EAST TOWN CROSSING

BUILDING 'A'

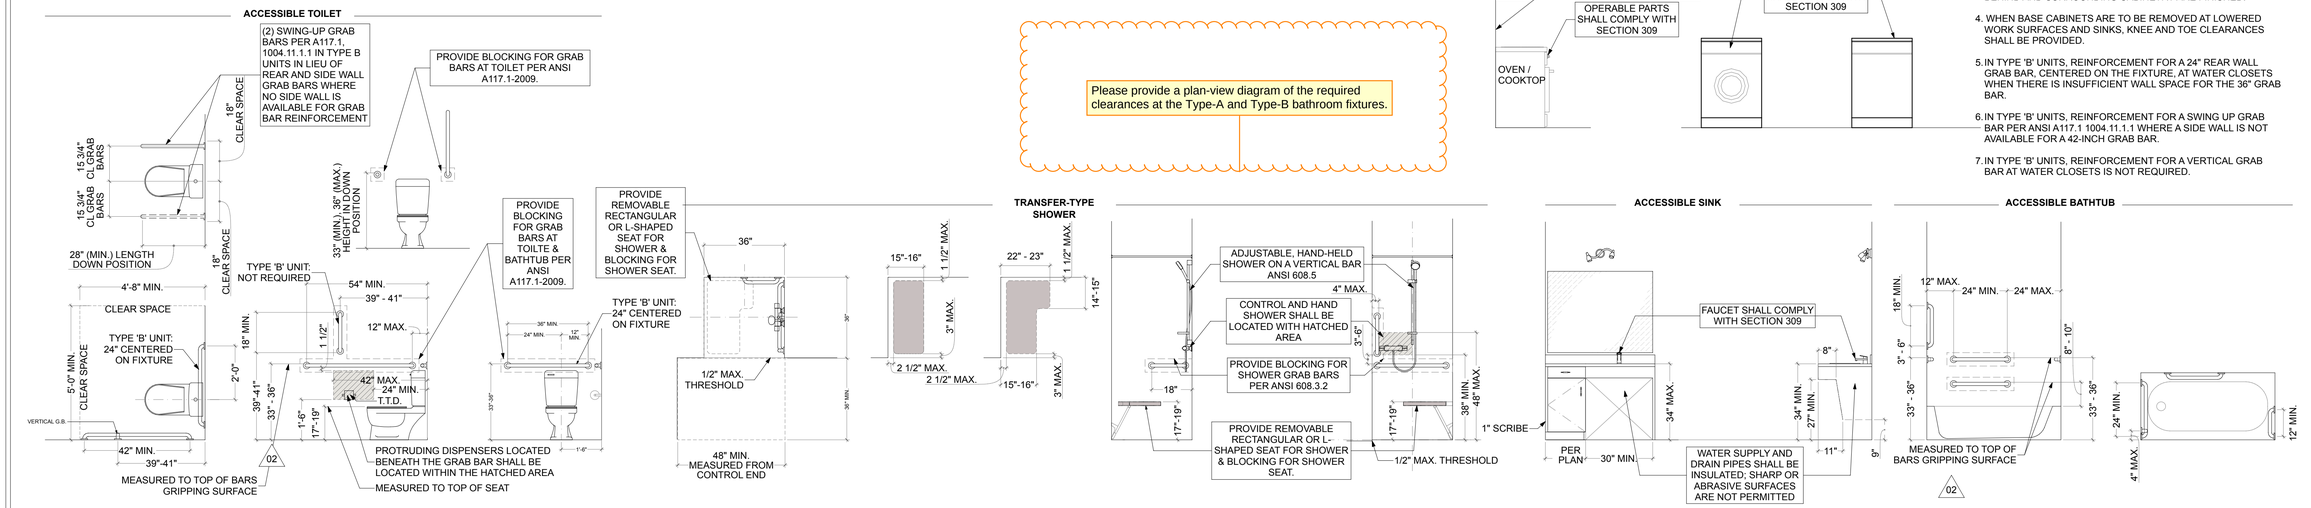
Sheet A1.0 notes the Type B bathrooms as Option B. Please confirm which is correct. Note: Option A requires all bathrooms in the unit comply with the standards listed under section 1004.11.3.1 of the 2009 Washington State Accessibility Code (A117.1-2009)

Please provide a plan-view diagram of the required clearances at the Type-A and Type-B bathroom fixtures.

6 ROOF ACCESS DETAIL
SCALE: 1 1/2"= 1'-0"

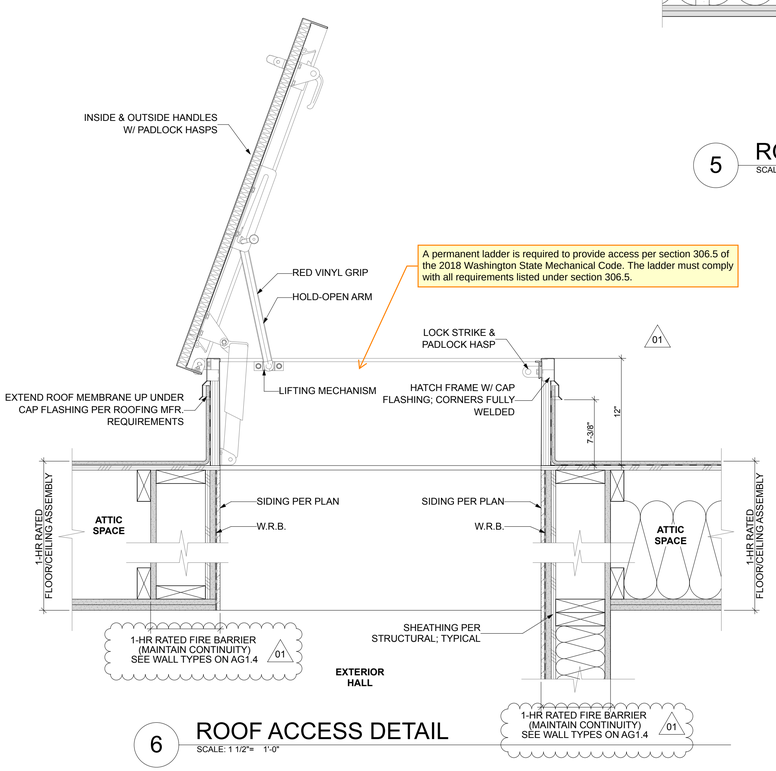
These notes have been cut off.
